Access Compliance Report Public Rights-of-Way (Curb Ramps)

Main Street: MESA_DR Cross Street: IRVINE_AVE Location: NE

ADA ID: RPRK211015140141 Ramp Type: Type 1 - Perpendicular Diagonal Initial Pass/Fail: Pass Overall Compliance: No Severity Score: 10

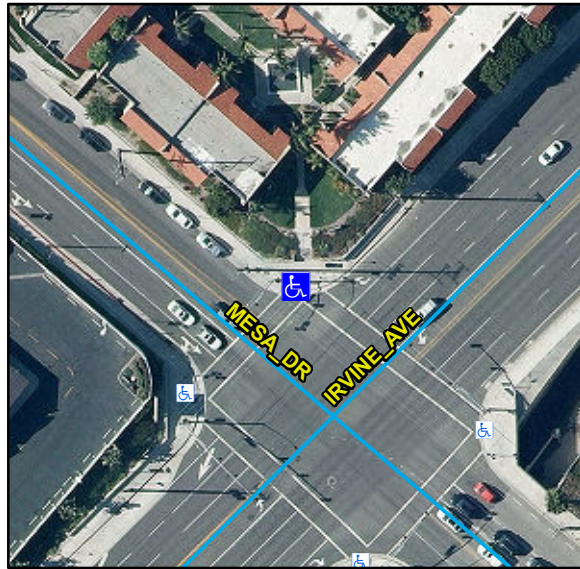
Compliance	Description	Data	Compliance	Description	Data
N/A	Ramp Length (in)	108	N/A	Flare Type LT	
Yes	Ramp Width (in)	50			Sloped
Yes	Ramp Run Slope (%)	2.3	Yes	Flare Slope LT (%)	6.7
Yes	Ramp Cross Slope (%)	1.5	N/A	Flare Traversable LT	Yes
N/A	Landing Present	Yes	N/A	Flare Type RT	
N/A	Landing Length (in)	57			Sloped
Yes	Landing Width (in)	48	Yes	Flare Slope RT (%)	7.1
No	Landing Run Slope (%)	4	N/A	Flare Traversable RT	Yes
Yes	Landing Cross Slope (%)	1.5	No	DWS Provided	No
N/A	Landing Movement Obstructed?	Yes	N/A	DWS Contrast	N/A
	Landing Movement Type	Stairs	N/A	DWS Length (in)	N/A
N/A	Landing Shared	No	N/A	DWS Full Width	N/A
N/A	Clear Space	Yes	N/A	DWS Offset Left (in)	N/A
N/A	Clear Space To Crosswalk (in)	48	N/A	DWS Offset Right (in)	N/A
N/A	Marked Crosswalk 1	No	N/A	Marked Crosswalk 2	No
	Crossing 1 Direction	W		Crossing 2 Direction	S
	Marked Crosswalk 1 Width (in)	N/A		Marked Crosswalk 2 Width (in)	N/A

N/A	Ramp Inside Crosswalk 1	N/A	Yes	Ramp Inside Crosswalk 2	N/A
	Crossing 1 Slope (%)	0.4		Crossing 2 Slope (%)	0.3
	Crossing 1 Cross Slope (%)	3.4		Crossing 2 Cross Slope (%)	0.8
Yes	Gutter Ponding	No	No	Curb Slope	12.1
Yes	Gutter Lip Height (in)	0		Road Run Slope (%)	3.3
Yes	Gutter Run Slope (%)	1.2		Road Cross Slope (%)	0.4
Yes	Gutter Cross Slope (%)	1.7			
Yes	Overall Surface Condition: Acceptable		Yes	Perp Joint Present	Yes
	Cross Gutter Present?	No		Spandrel Present?	No
	Replace Cross Gutter?	N/A		Replace Spandrel?	N/A

Remove & Replace Curb Ramp With Two New Directional Ramps or Equivalent.
